- Request - Special Use Permit for Used Auto Sales Lot
- Location - 2204 N. Reynolds Road
- Applicant - Chafic Elkhechin  
2204 N. Reynolds Road  
Toledo, OH 43615
- Architect - Angela Holm  
Architecture by Design, Ltd.  
5622 Mayberry Square  
Sylvania, OH 43560

The staff recommends that the Toledo City Plan Commission recommend approval of SUP24-0007, the request for a Special Use Permit for a Used Auto Sales Lot at 2204 N Reynolds Road, to Toledo City Council, for the following three (3) reasons:

SPECIAL USE PERMIT  
TOLEDO CITY PLAN COMMISSION  
REF: SUP24-0007  
DATE: February 13, 2025  
TIME: 2:00 P.M.

# SITE PLAN

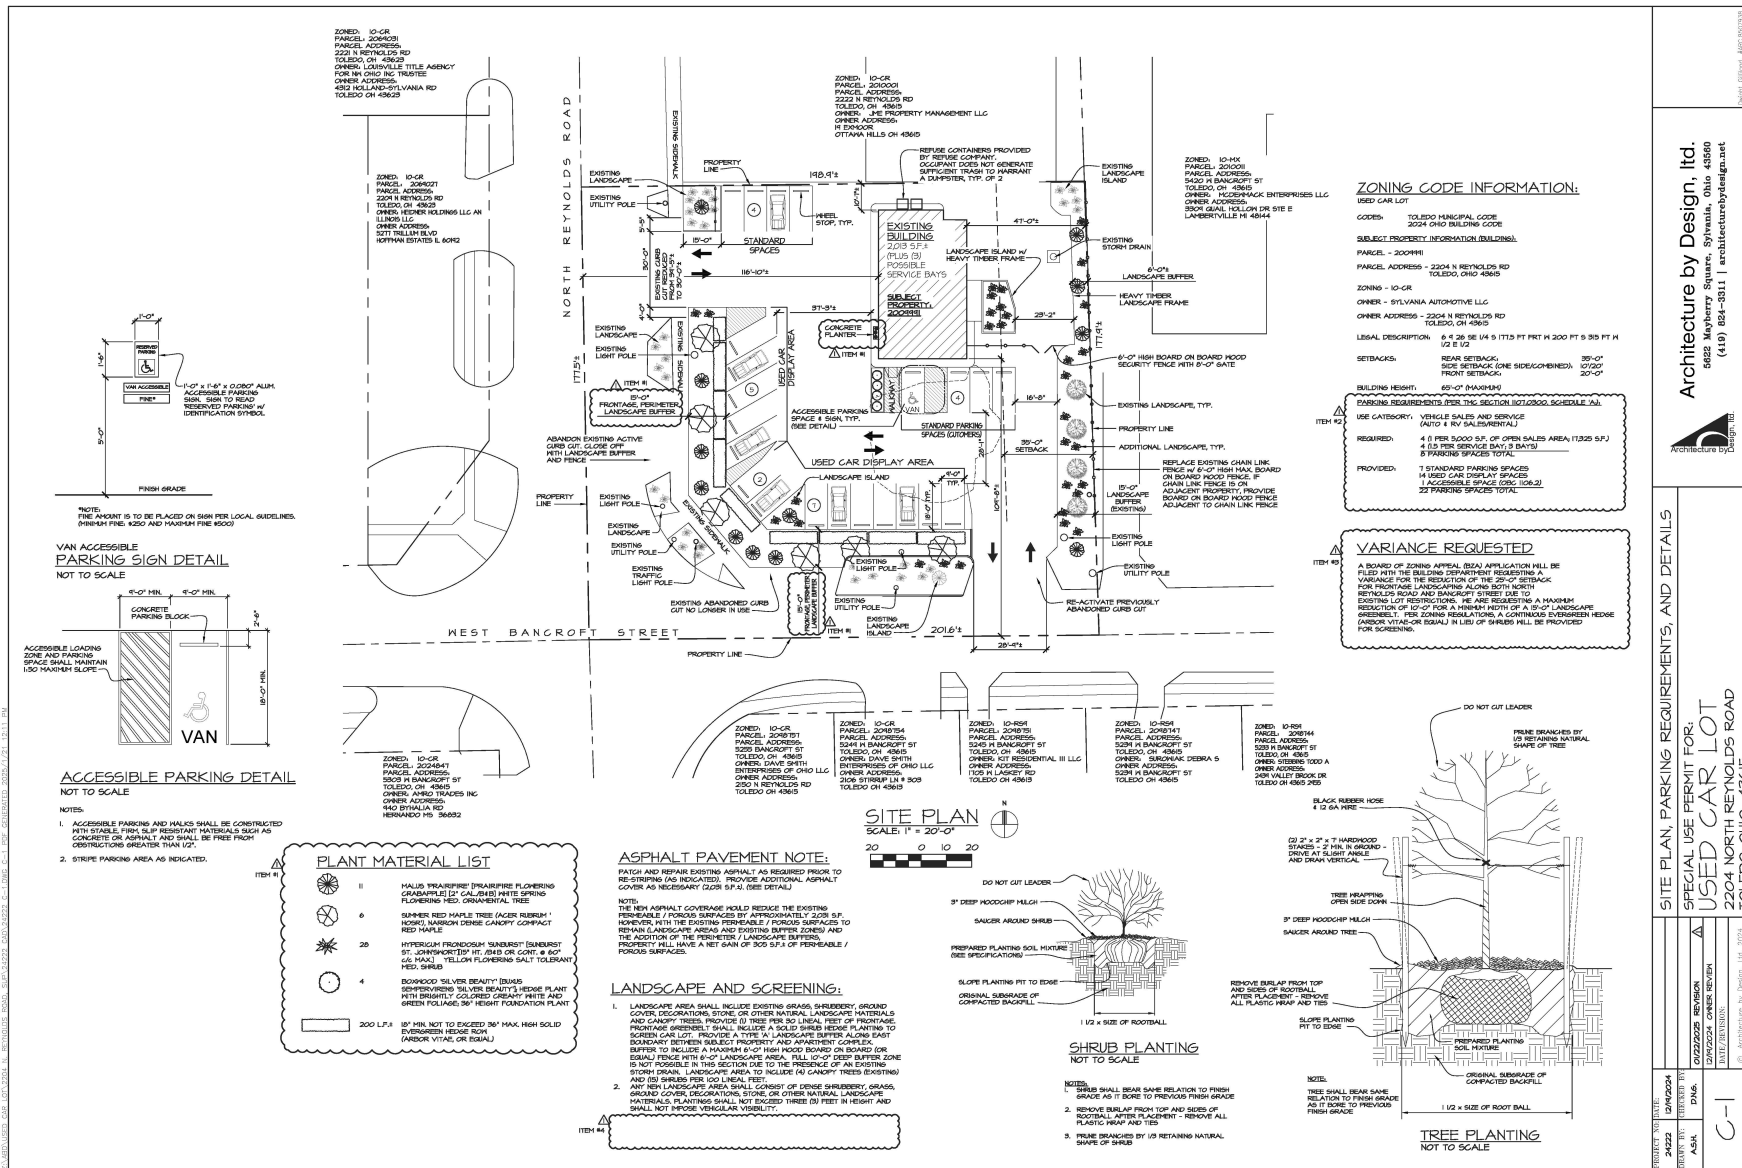
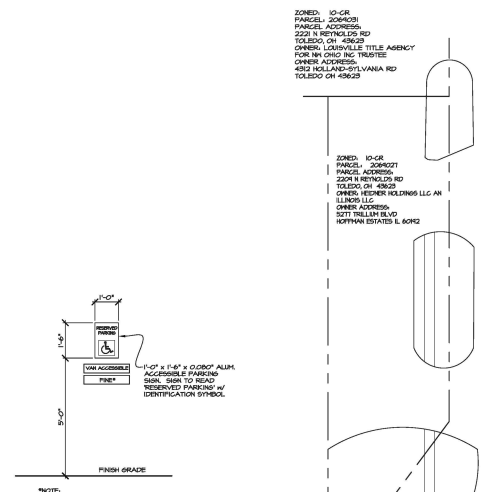
8. Pursuant to TMC§1104.0308, all vehicles on display must be parked in striped parking spaces that shall be designated on an approved Site Plan. Vehicle parking that deviates from the approved Site Plan shall not be permitted. **Acceptable as depicted on site plan.**

12. Per TMC§1104.0301, a fifty-foot (50') separation measured along the street frontage between any open display sales lot and a Residential district boundary line shall be maintained. This separation shall apply to both side of a street and to intersecting streets on corner lots. **Acceptable as depicted on site plan.**

13. Sidewalks are required along West Bancroft through drive apron to property line per **TMC§1107.1303. A revised site plan shall be submitted showing this modification.**

16. Pursuant to TMC§1108.0203(G), dumpster and trash receptacle location(s) shall be clearly defined, have a concrete pad and be surrounded by a six-foot (6') solid fence or a masonry screen enclosure with landscaping and shall not be located in any required setbacks or within the public right-of-way. **Not acceptable as depicted on site plan. The refuse containers shown on the site plan shall be screen and shown on a revised site plan.**

- b. A Type “A” landscape buffer is required along the eastern property lines. A ten-foot (10’) wide buffer with six (6) trees and twenty-three (23) shrubs is required along the eastern property line. **Not acceptable as depicted on site plan submitted. The buffer shall be extended to ten-feet (10’) wide while making reasonable accommodations for the existing storm drain and shall be provided and shown on a revised landscaping plan.**

- c. Dumpster and trash receptacle screening is required per TMC§1108.0203. **Not acceptable as depicted on site plan.**

- e. Interior parking lot landscaping per TMC§1108.0204. Four (4) canopy trees and 12 shrubs are to be provided. One (1) tree and 8 shrubs are depicted on the landscape plan. **Not acceptable as depicted on site plan submitted. Three (3) additional canopy trees and four (4) shrubs shall be provided and shown on a revised landscaping plan.**

- f. Interior parking lot landscaping design standards per TMC§1108.02204(B). Landscaping areas within the parking area must be constructed with six-inch (6") by eighteen-inch (18") concrete curbing, cast-in-place, extruded, or by some other process approved by the Planning Director, in order to minimize damage to plant material. One (1) of the landscaping islands barriers proposed the use of heavy timber frames. **Not acceptable as depicted on landscaping plan submitted. The landscaping barriers shall be modified and shown on a revised landscaping plan.**
